Advanced LIGO Engineering Change Request (ECR)

ECR Title: PSL PD Assembly (Bug 71)

DCC No: E1300122-v2

ECR – Rework to PSL, ISS PD Assembly (Bug 71)

Figure (1) – (Above) Photo of existing PD and housing minus connector (and minus Kapton washers)
Refer to LIGO-E1300167: [DCN, Initial release of Aligo, IO, PSL ISS PD Connector Assembly & associated Docs.](#)

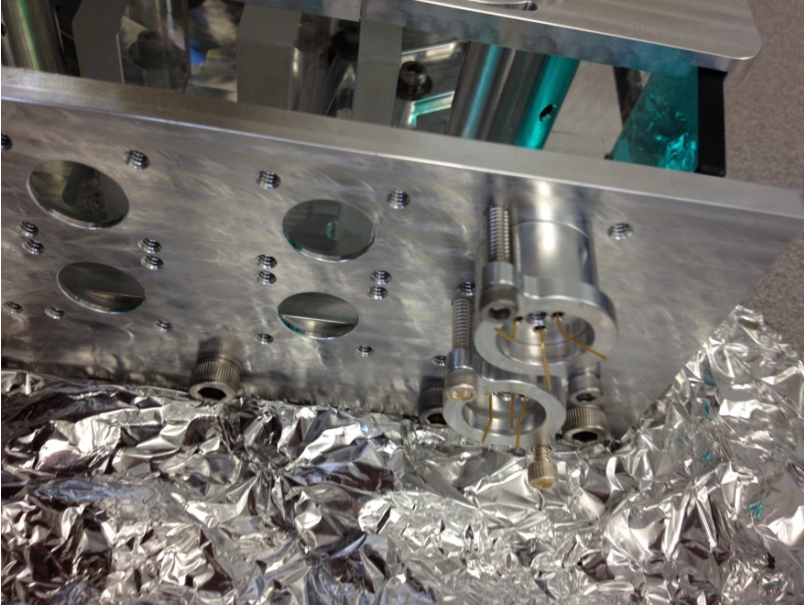
- 1) (In progress) Teflon (or PEEK) tubing will be added around the PD pins as an electrical insulating sleeve.
- 2) (In progress) New cable – New cable connections will be retrofitted onto the ISS PD Array cable (crimped ferrule connection rather than a soldered joint. (This is shown in the picture below.) - **Complete**

- 6) (To be started) Kapton washers – the team also notes that they need to confirm the use of Kapton washers to electrically insulate the diode holding cylinder

Figure (2) – (Above) Photo of proposed new cable connector and PC board
Refer to LIGO-E1300167: [DCN, Initial release of Aligo, IO, PSL ISS PD Connector Assembly & associated Docs.](#)

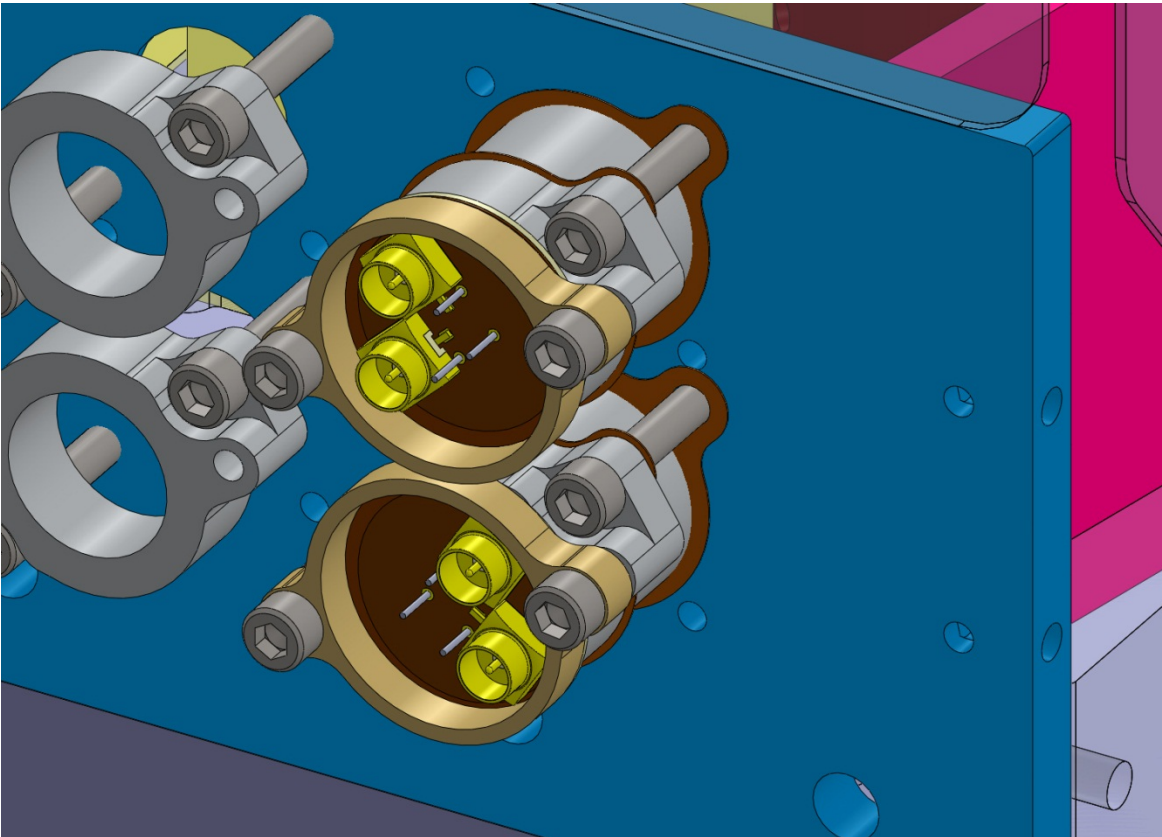
- 3) (In progress) New connector on array – The current baseline plan now is to change the method of connecting the cable to the PD Array. This involves the re-design of the PD clamping housing. (This is shown in the picture below.) – **refer to DCN above**

- 4) **(In progress) New connector on QPD Array, refer to DCN above.**
- 5) (To be started) Cable at flange – the team notes that the question of the inability to connect the ISS cable to the flange has not yet been fully addressed. A spare ISS PD cable has been requested to be shipped back from LLO. Once the cables arrives at CIT we will test the mating to the vacuum flange with and replace the SMP connectors with the new ferrule connectors mentioned above. – **Complete, see pictures and video at DCC link of this doc.**
